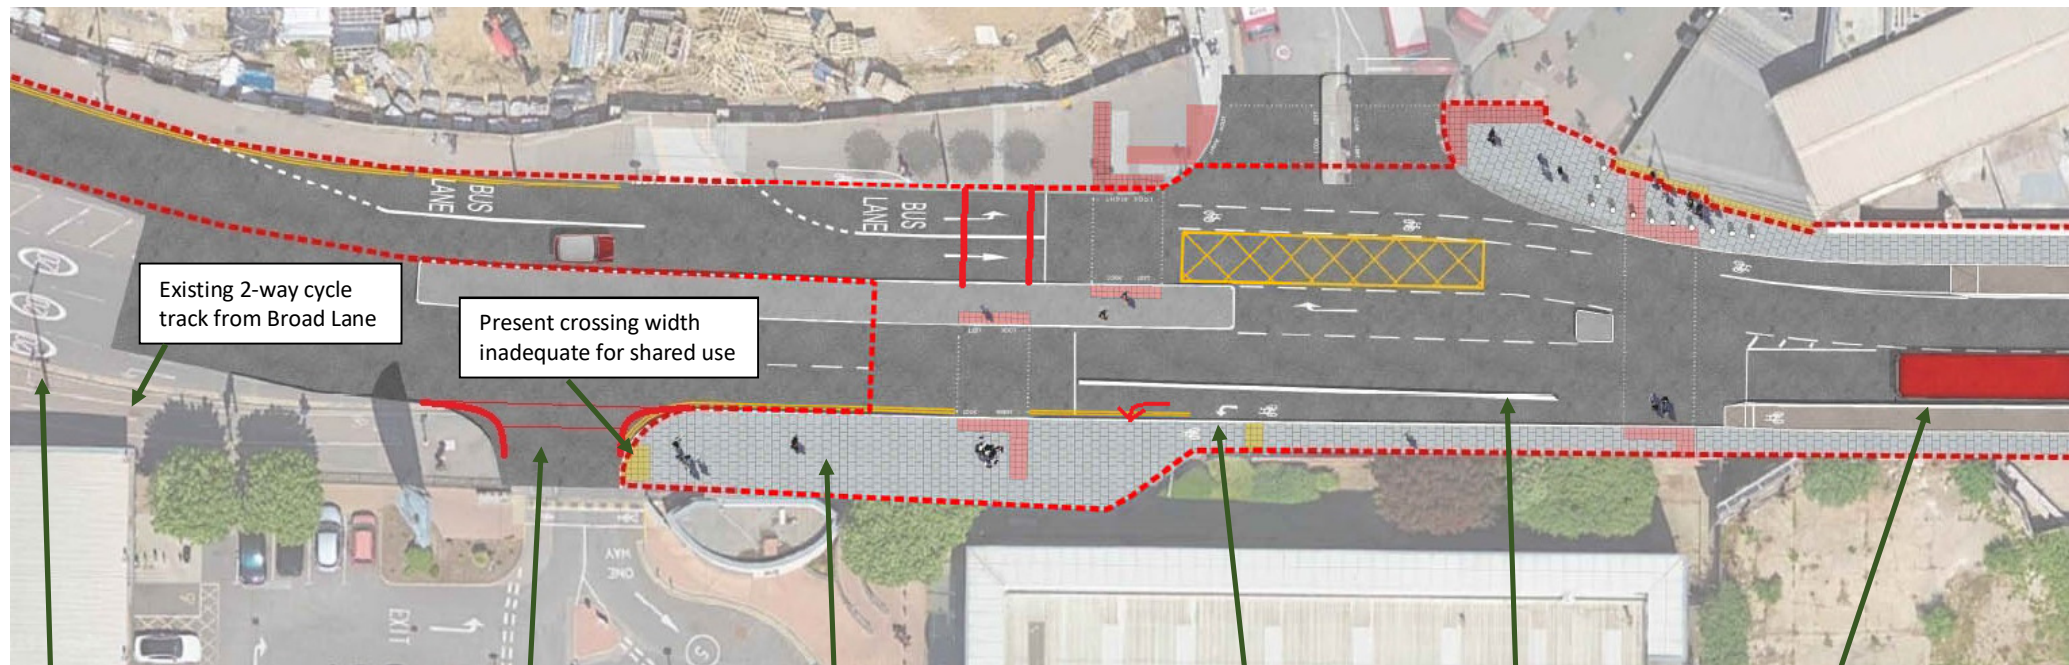
1. Extend 20mph limit to bridge E approach

2. Tighten kerb radii and form Copenhagen crossing (NB the Broad Lane entrance is suitable for HGV access)

3. Cycles from Broad Lane tend to continue E on S side of bridge- resulting in pedestrian conflict. Signpost and provide straight-across crossing to N side, to facilitate changeover

4. Pavement too narrow for shared use, move cycle access

5. Please confirm protection of cycle lane

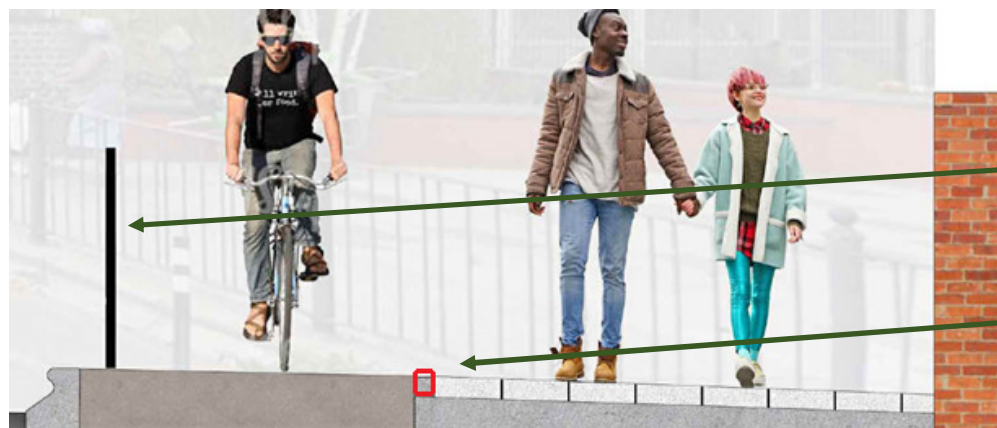
6. Please confirm reason for proposed drop kerb for vehicle access

7. LTN1/20 compliance requires increased cycle lane width adjacent to vertical barrier. Suggest increase lane width (presently 1.5m) or remove barrier

8. Chamfer edge raised strip, or other feature needed to assist visually impaired and emphasise pedestrian separation (effect on drainage needs consideration)
